Access Compliance Report

Public Rights-of-Way (Curb Ramps)

Intersection ID: 8193	Main Street: E_W_T_HARRIS_BV	Cross Street: GRIER_RD	Location: SW
ADA ID: EDE060F4C206	Ramp Type: Directional1	Initial Pass/Fail: Pass	Overall Compliance: No
Severity Score: 0			
Codes/Mitigation Info/Possible Solution		Field Measurements/Component Compliance

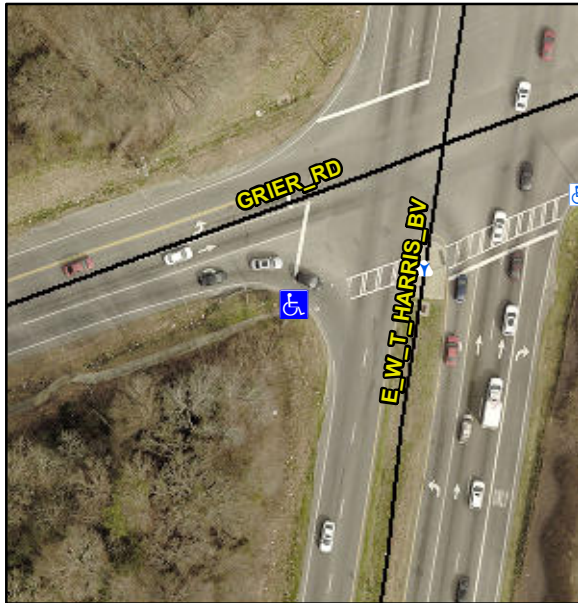
**Remove & Replace Landing. Gutter
Ponding Observed.**

**R304.2.2-Perp, R304.3.2-Para,
R302.7**
